—
P21110-FCH-XX-XX-RG-A-0003
PLANNING APPLICATION PROPOSED AMENDMENTS - OVERVIEW
APPLICATION REF: 120149/FO/2018

Planning Application Proposed Amendments - Overview

DUCIE STREET, MANCHESTER

This document provides an overview of proposed variations to the planning consented scheme '120149/FO/2018'.

Ground Floor Plan - Proposed Amendments 1:200

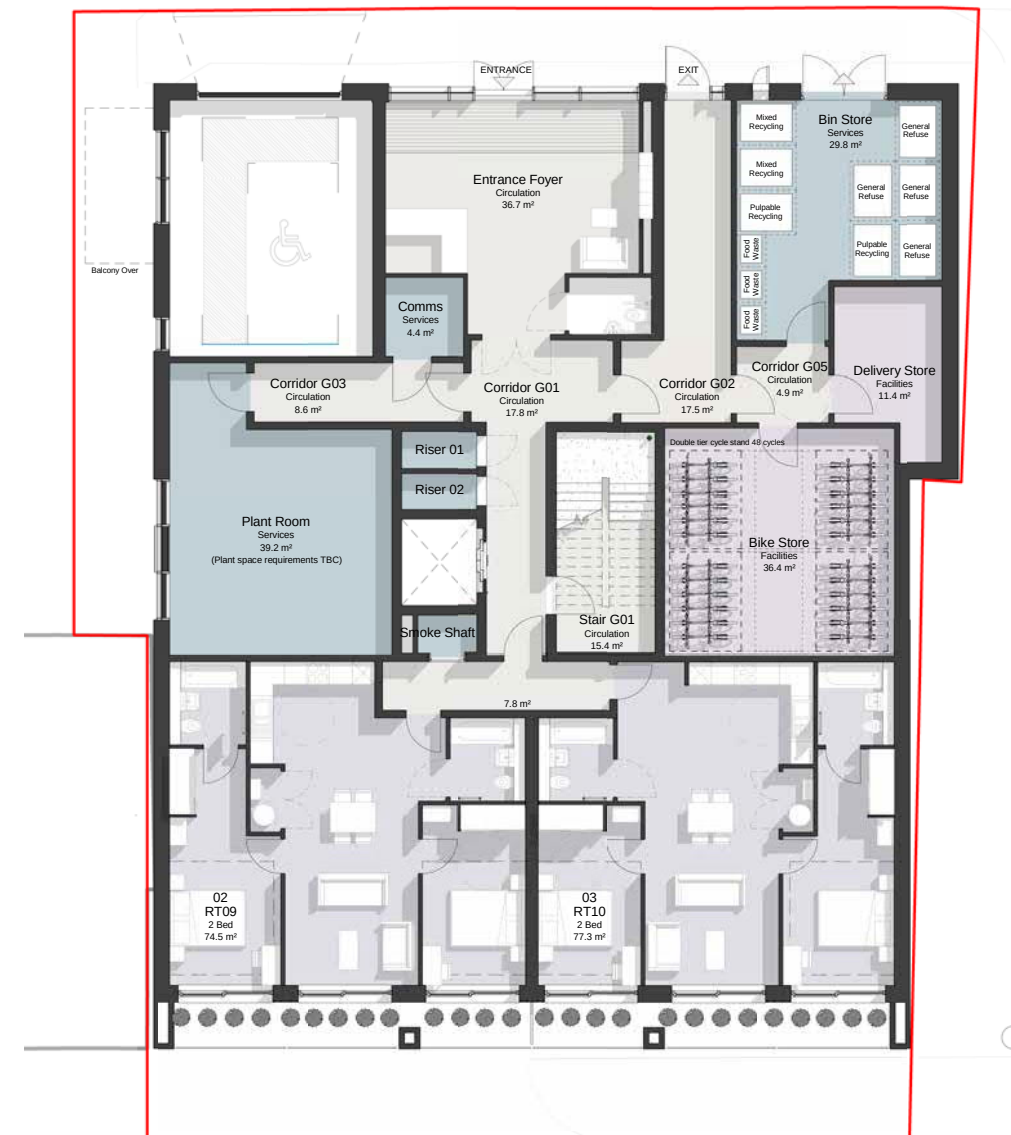
04. Amend location of roller shutter door and plant room louvred panels to suit internal layout amendments.

Reconfiguration of the ground floor internal layout was required in order to accommodate:

- a switch room
- a life safety room
- a generator room

North West Elevation - Proposed Amendments 1:200

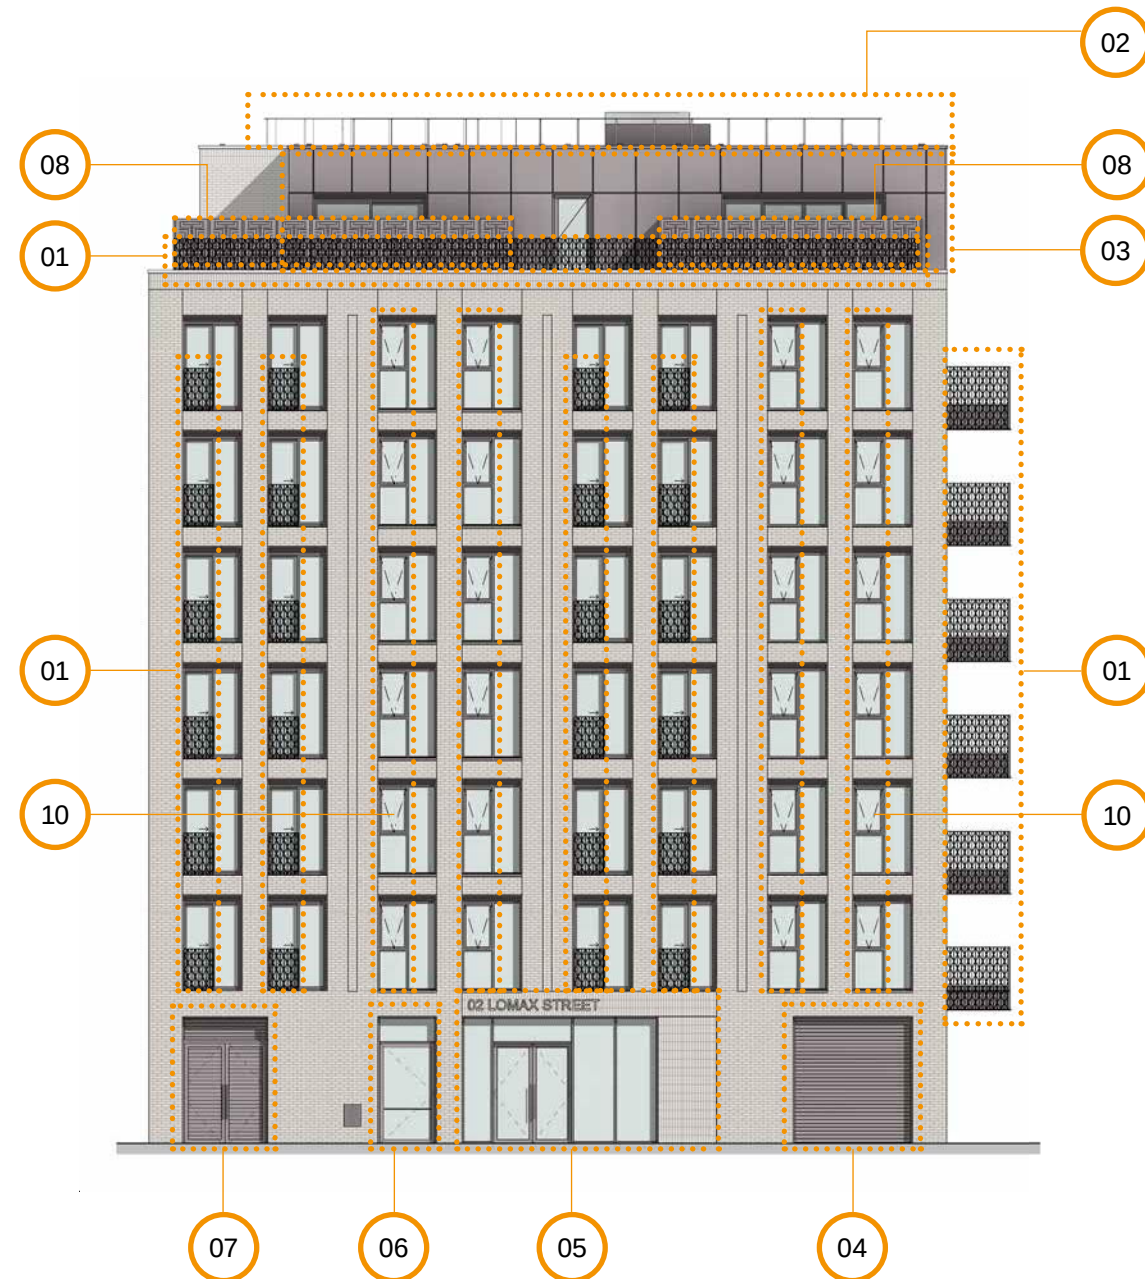
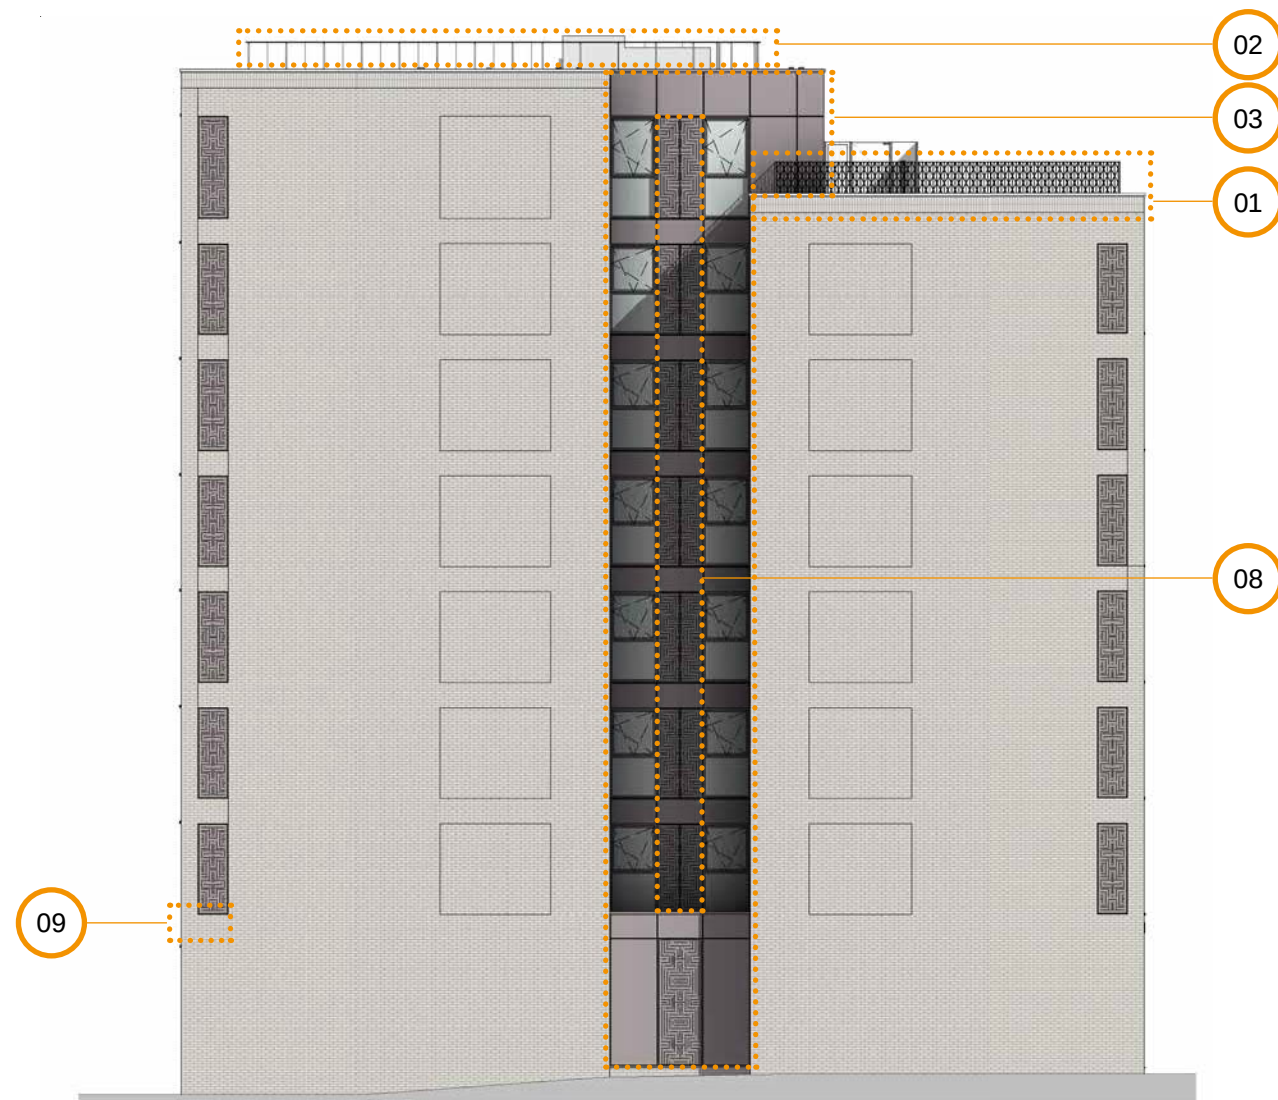
- 01. Change the balcony balustrades from frameless glass to metal railing to suit Building Regulation approval requirements.
- 02. Add collective edge Protection to Roof level.
- 03. Re-set out metal cladding panels to suit manufacturing constraints.

North East Elevation - Proposed Amendments 1:200

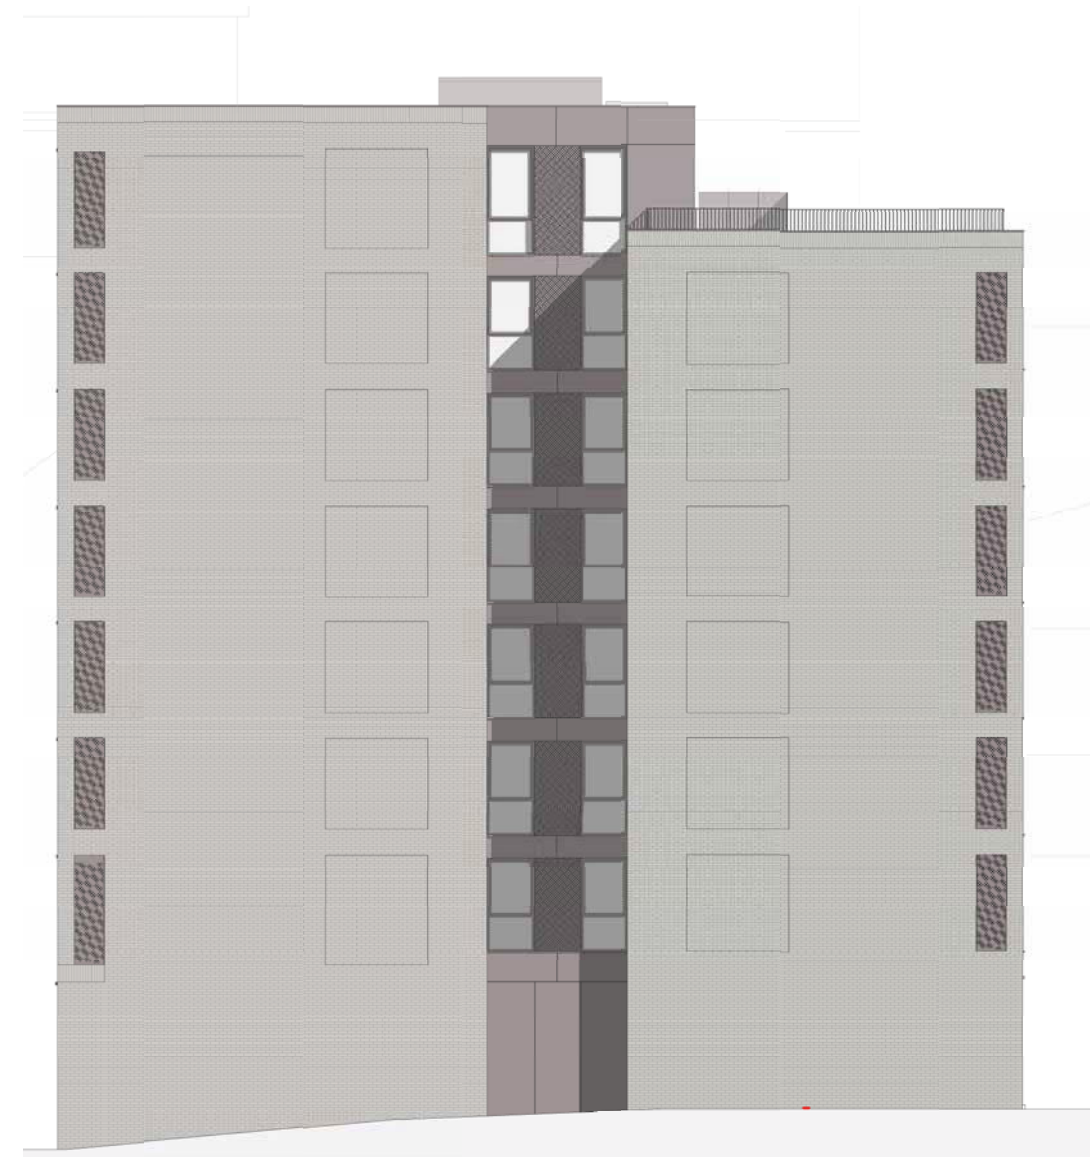
- 01. Change the balcony balustrades from frameless glass to metal railing to suit Building Regulation approval requirements.
- 02. Add collective edge Protection to Roof level.
- 03. Re-set out metal cladding panels to suit manufacturing constraints.

South East Elevation - Proposed Amendments 1:200

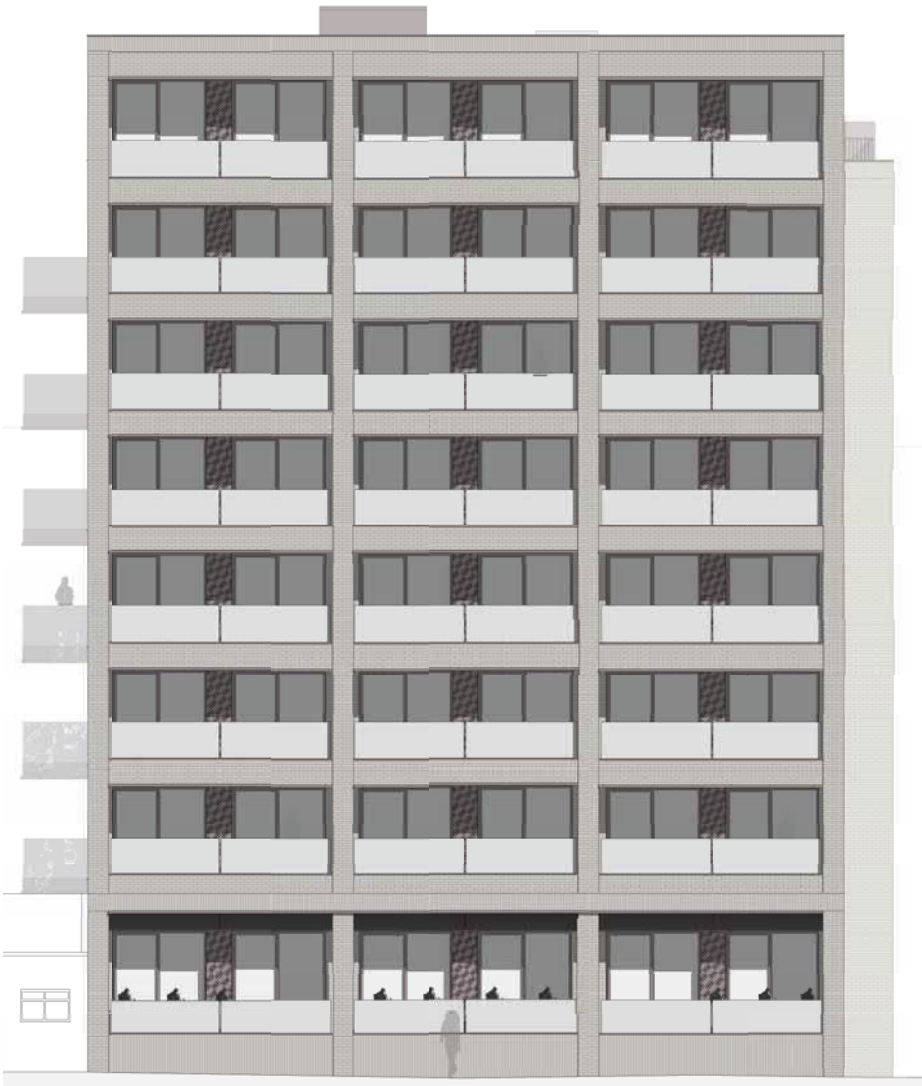
- 01. Change the balcony balustrades from frameless glass to metal railing to suit Building Regulation approval requirements.
- 02. Add collective edge Protection to Roof level.
- 03. Re-set out metal cladding panels to suit manufacturing constraints.

South West Elevation - Proposed Amendments 1:200

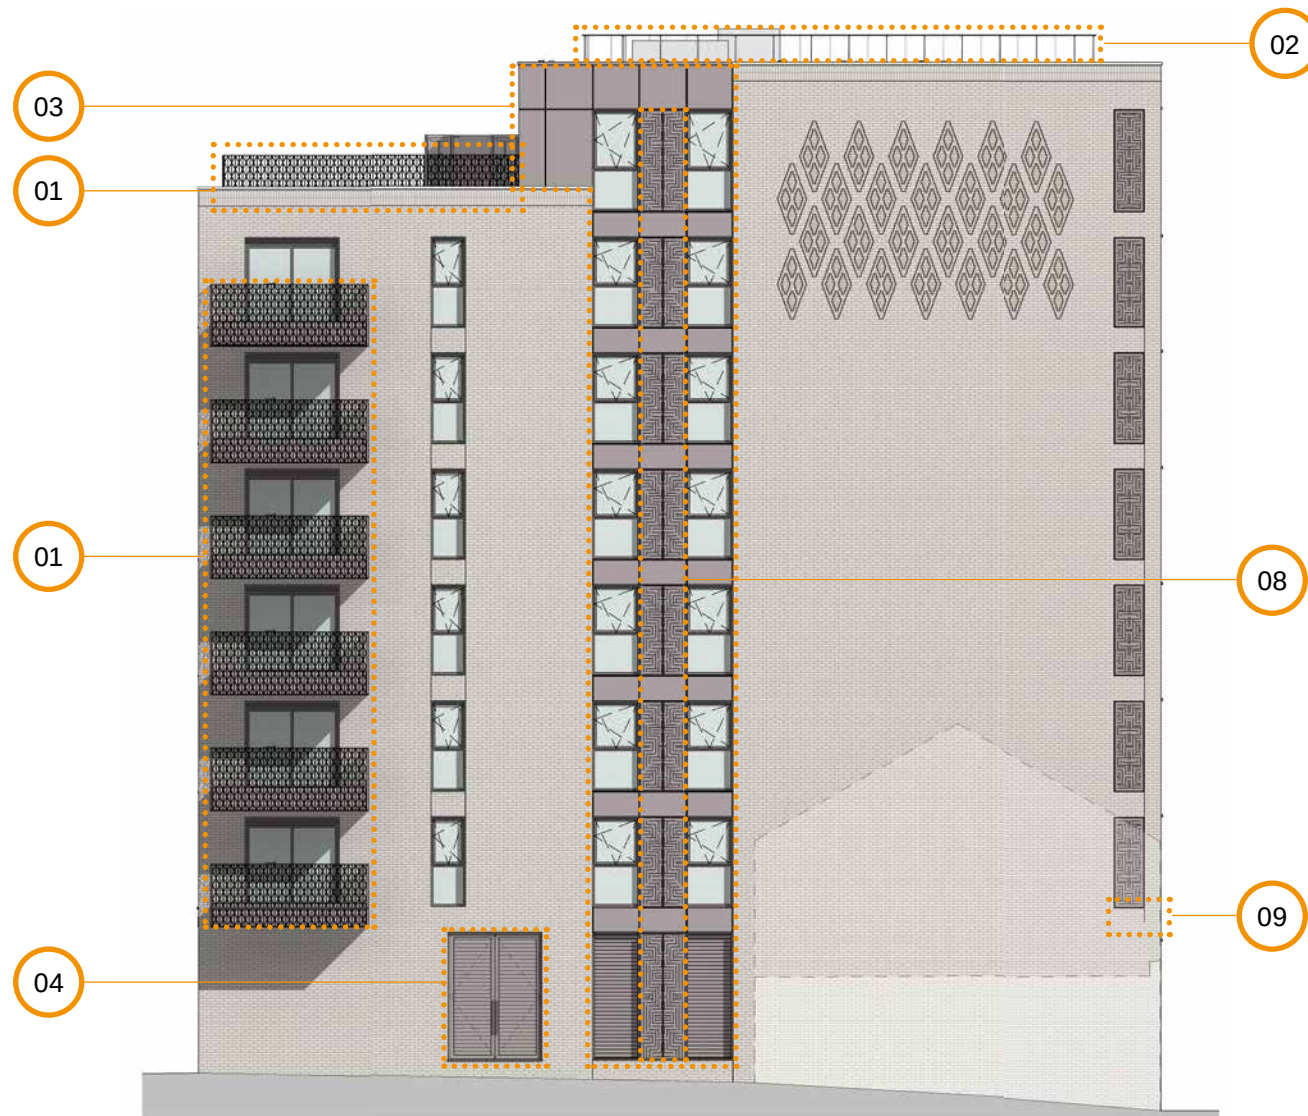
- 01. Change the balcony balustrades from frameless glass to metal railing to suit Building Regulation approval requirements.
- 02. Add collective edge Protection to Roof level.
- 03. Re-set out metal cladding panels to suit manufacturing constraints.

Item 01. Elevation Details - Railing Design Proposal (Refer to Appendix A)

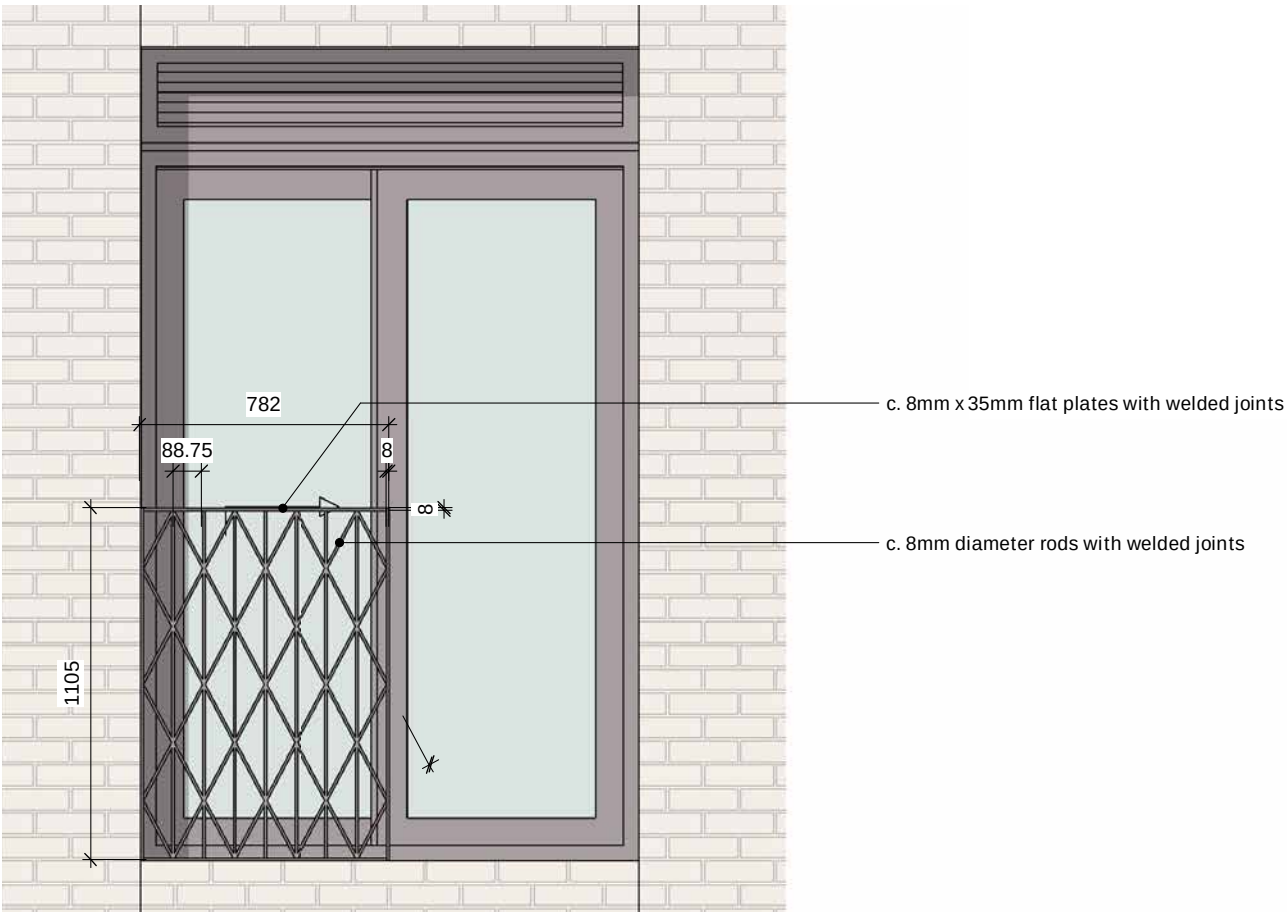
The proposal is to amend the glazed balustrades to angled metal rod ballusters arranged in a bespoke design with flat top, base and side rails. The metal would be in a tone and finish similar to the metal cladding.

Fixings will be as per the frameless glass balustrades, for the recessed and projecting balconies this would be down to the structural slab. For the Juliette balconies this would be to the window frame with colour matched capped screws.

Item 08. Elevation Details - Perforated Panel Proposal (Refer to Appendix B)

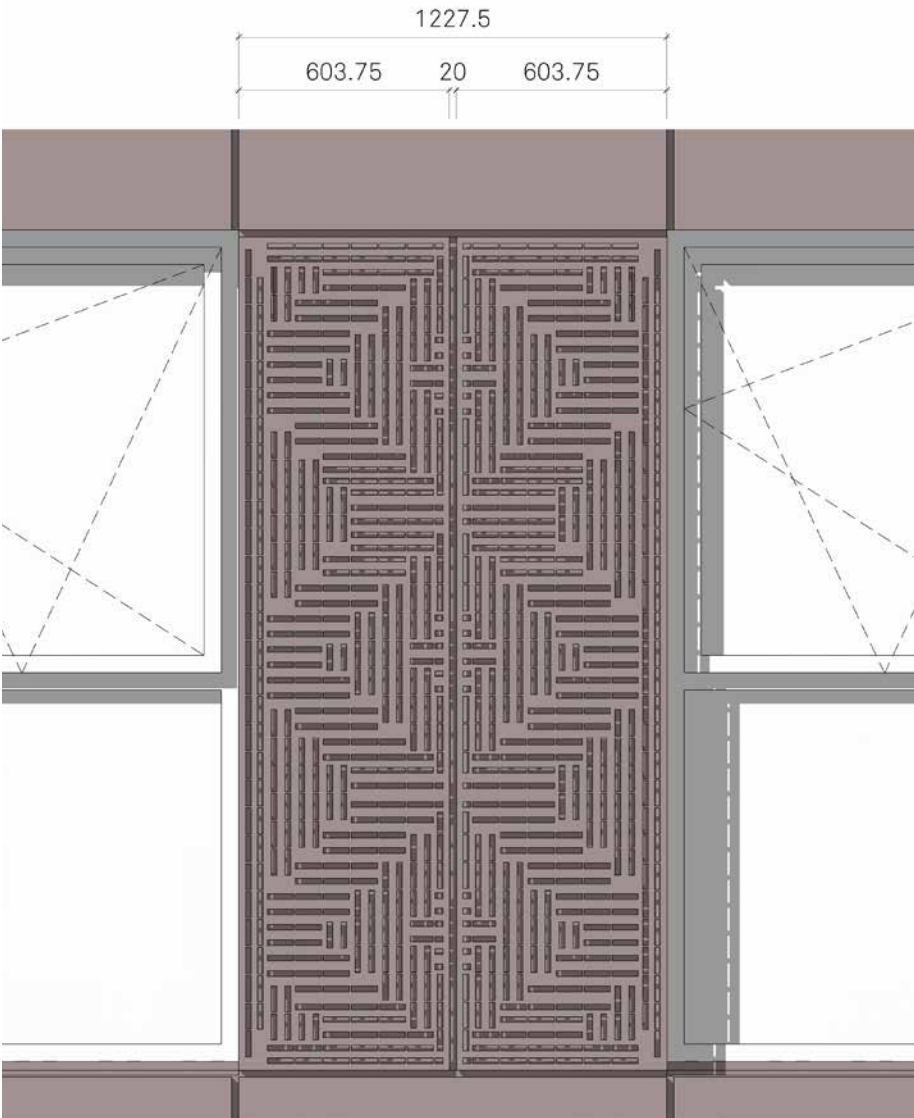
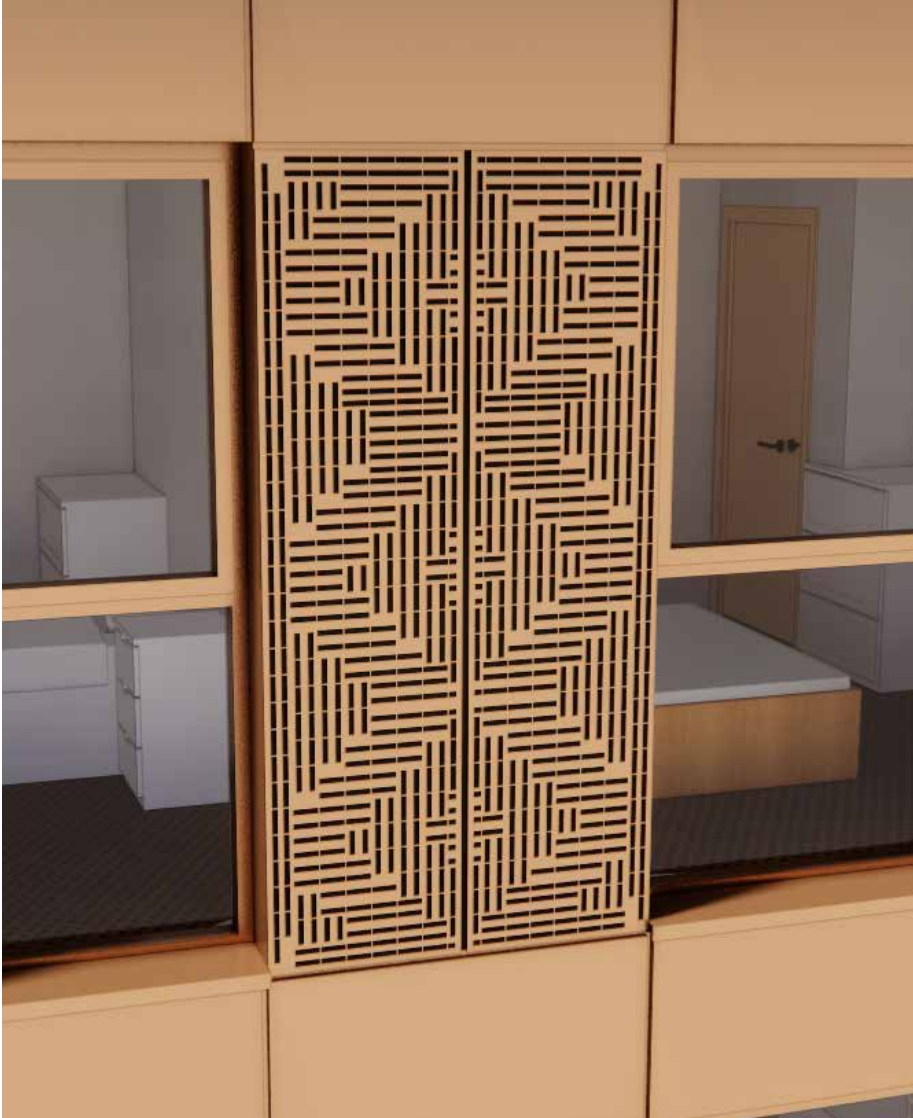
08. Split perforated panels on north-east & south-west elevations and roof privacy screens due to manufacturers limitations.

Please refer to pages 6-9 for comparative elevations showing the metal cladding panels. Panels have been split vertically in the centre to limit visual impact of the new joint.
